# MEMORANDUM

SUBJECT: Site Plan Approval – 1068 Arsenal Street

DATE: July 31, 2025

**Request:** Site Plan Approval to construct a 510 square-foot (SF), drive-through coffee shop, a 388 SF storage building and associated site improvements at **1068 Arsenal Street**, Parcel Number 8-47-106.200

C4.1  
UTILITY PLAN

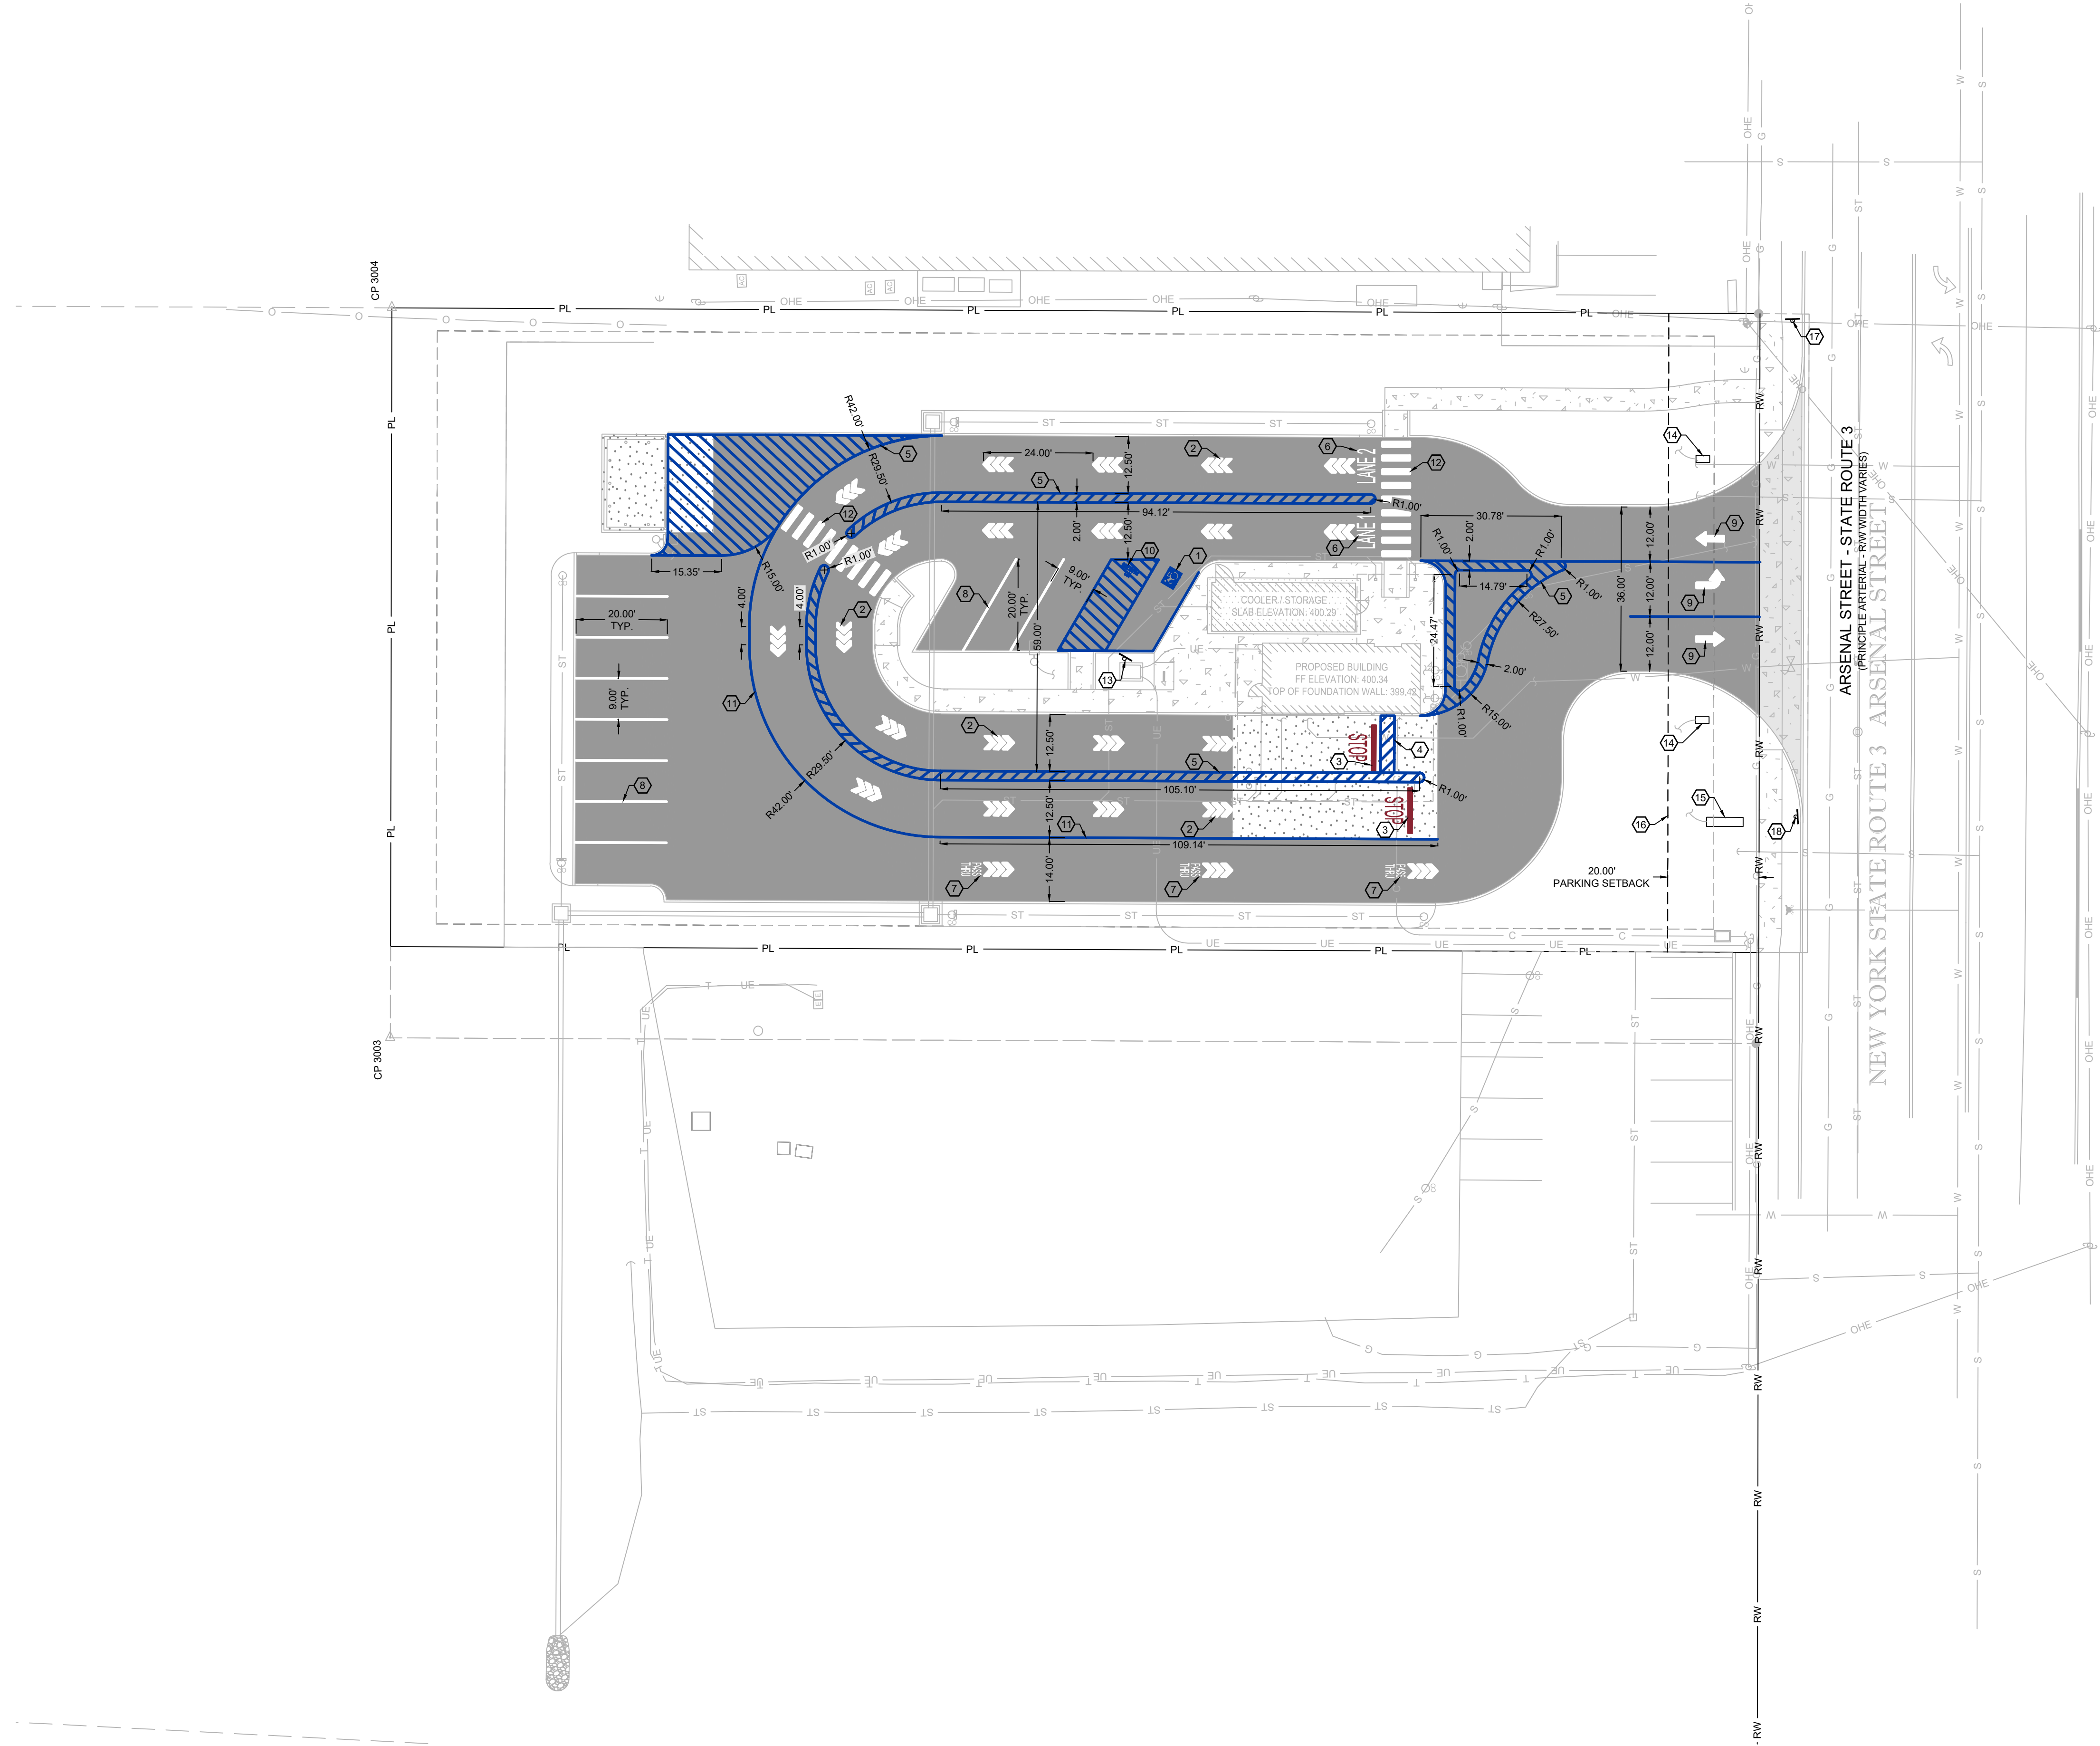
- Sheet C4.1 – Utility Plan
  - *Note 7 calls for connection of the 4” sanitary sewer, however no cleanout is called for. It is typical for the contractor to provide a sanitary cleanout at the reconnection point.*

- *The stormwater discharge is directed to a NYSDOT drainage swale. The City will require acknowledgement and acceptance from the Department prior to site plan approval.*

- *Note 26 references a nonexistent detail on sheet C7.2*
  - *Note 28 references a detail for concrete end section on sheet C7.3. The connecting pipe is 12” HDPE. How do the two connect?*

- The Project will require NYSDOT Highway Permit.
- Project will require a Stormwater Discharge Easement (and maintenance agreement) from the adjacent property owner and NYSDOT. A water quality basin is required to treat stormwater leaving the site.
- The City of Watertown requires the submittal of an Engineering report of sanitary discharge flows due to the City's Consent Order from the DEC.
- Sheet C3.1 – Pipe inverts are required.
- Sheet C7.2 - No concrete Blocking under Sewer Piping.
- Sheet C4.1 – Hydrant does not meet City of Watertown's Specification.

Response: All pipe inverts are labeled through keynotes on revised C4.1, Utility Plan.

Response: The hydrant has been updated to meet City of Watertown specifications. See revised C4.1, Utility Plan.

C6.1  
STRIPING PLAN

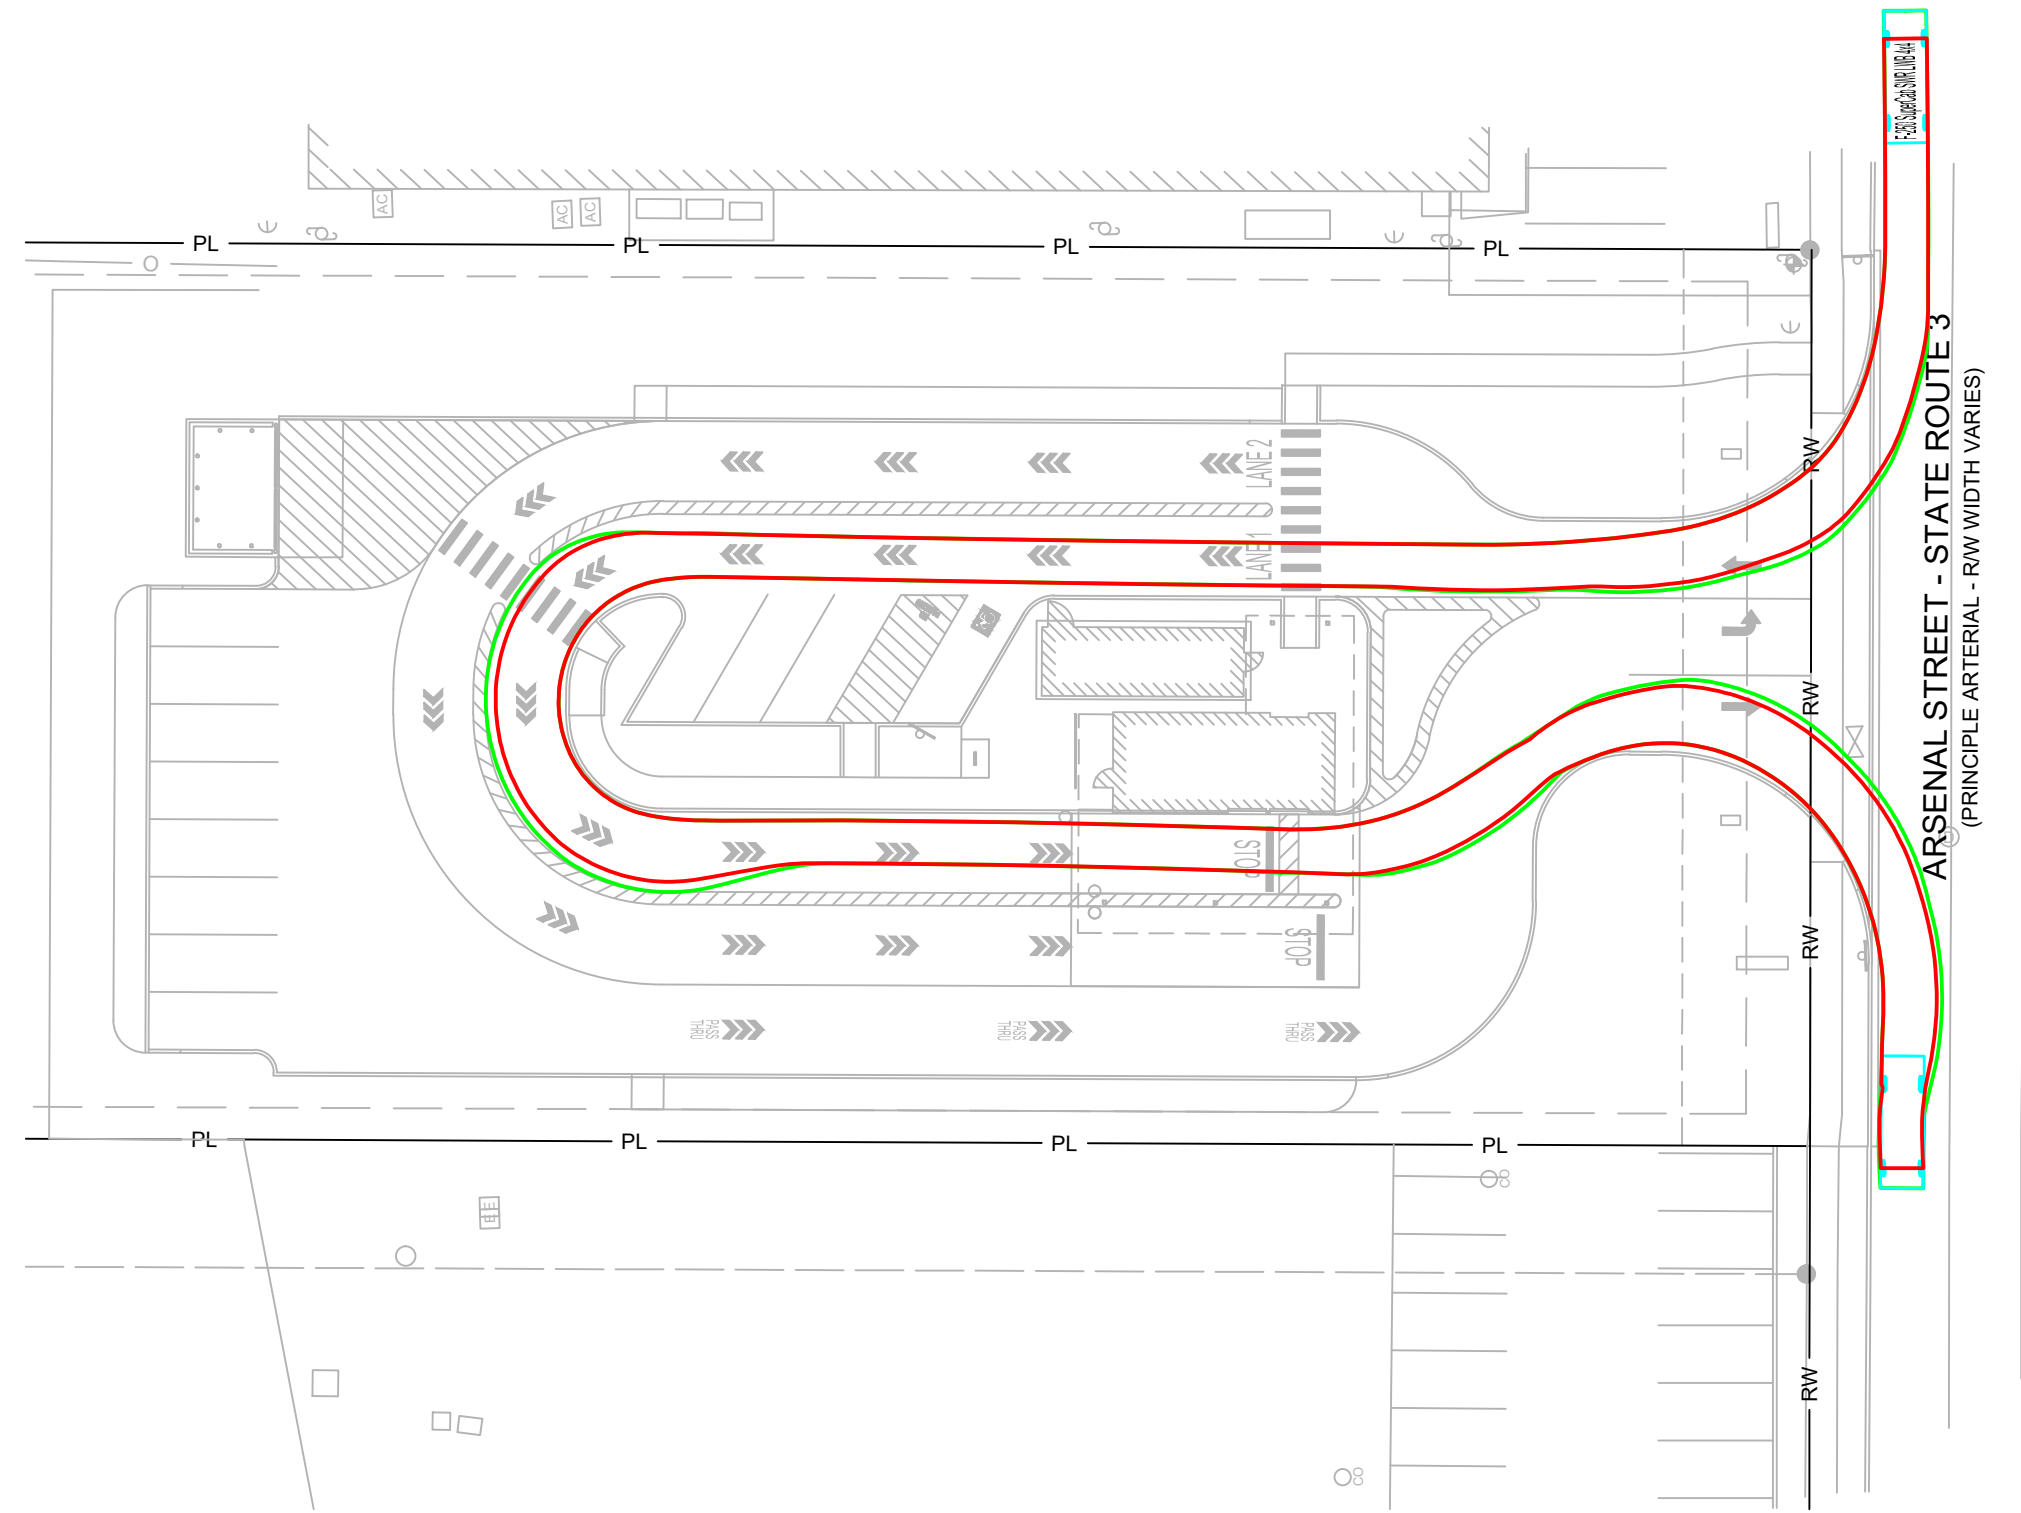
- Sheet C6.1 – Striping Plan
  - *Paint striping at the entrance delineating site circulation is insufficient during winter months and will likely wear. Consider concrete curb installation with delineation markers. This could provide additional green space and/or snow storage and increase on-site infiltration.*

4.12 FIRE HYDRANT PER CITY OF WATERTOWN WATER WORKS DETAILS DT-3  
SCALE: NONE

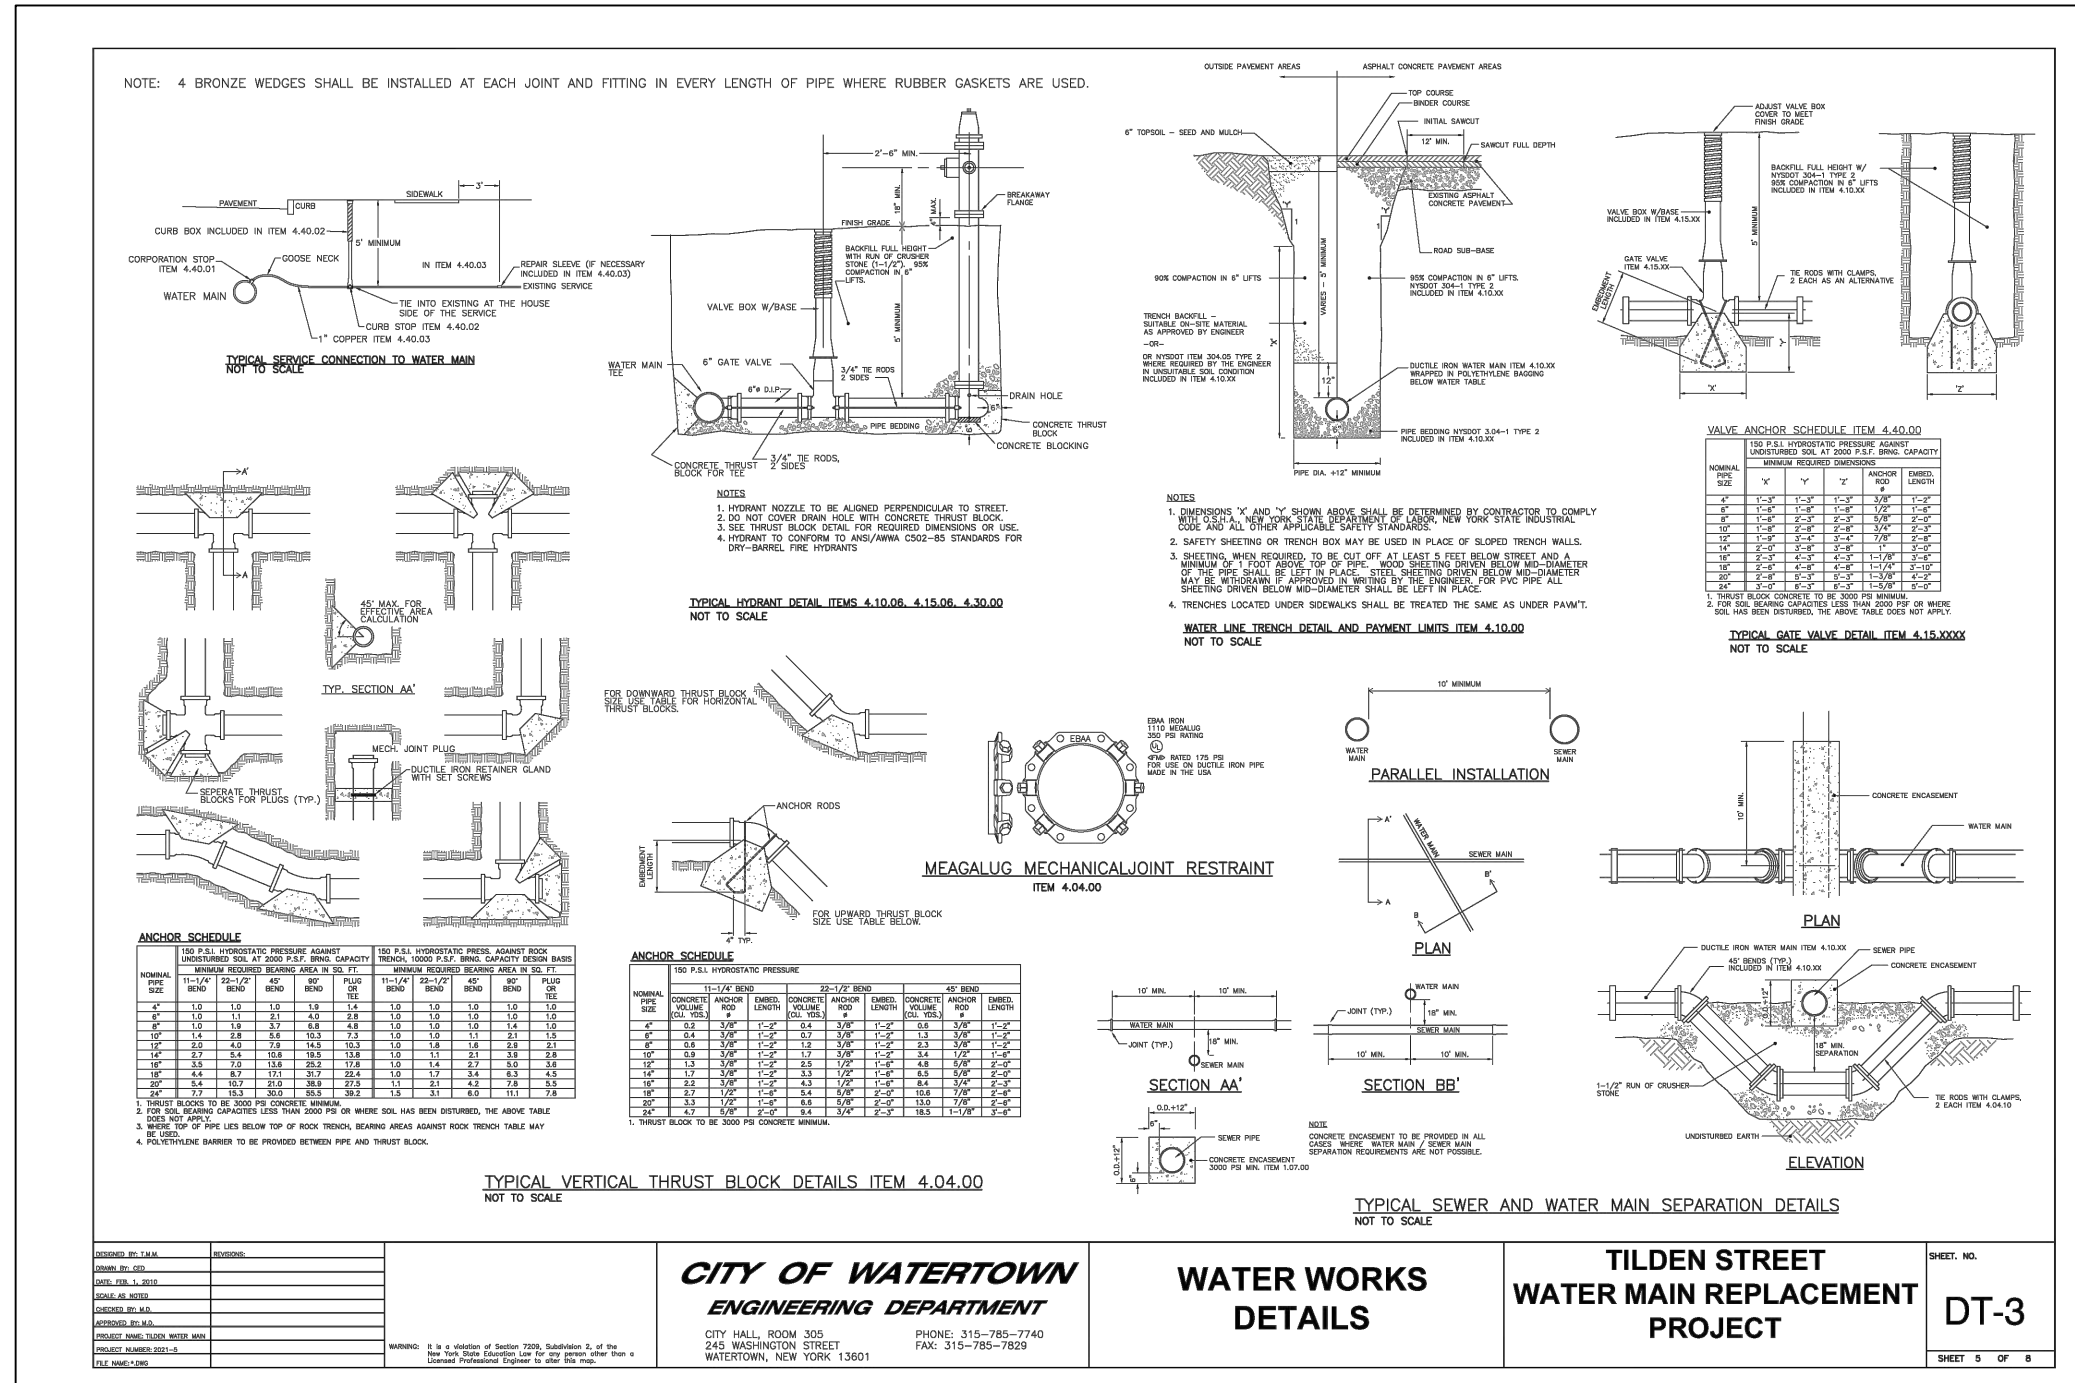
- Sheet C7.4 – ROW Details
  - *Detail no. 4.12 should be removed. This was provided as an example of a City typical for hydrant installation. It was not intended to be included on the design set prepared by your professional consultant. Attached please find the standard specification and brochure for Kennedy hydrants, which is the City required hydrant. Our spec is for a Kennedy K-81D and we also require the factory Storz connection (not detailed on this cut sheet).*
